TRANS/WP.29/GRRF/2003/24
4 July 2003

PROPOSAL FOR AMENDMENTS TO REGULATION No. 106
(Agricultural tyres)

Transmitted by the Expert from the European Tyre and Rim Technical Organization (ETRTO)

Annex 10, the table, insert two new rows to read:

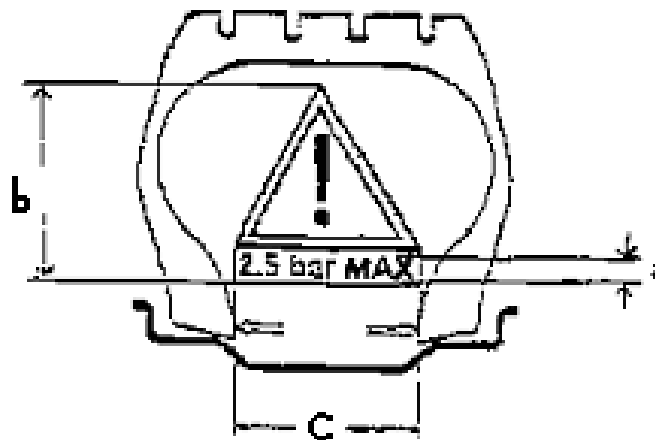
Classification code	Nomenclature
.....
I-6	Agricultural implement tyres : Smooth tread
LS-1	Logging and Forestry Service Tyres : regular tread
LS-2
LS-3
LS-4	Logging and Forestry Service Tyres : shallow tread
.....

The two additional classification codes (LS-1 and LS-4) for logging and forestry service tyres complete the possible cases and identify new developments.
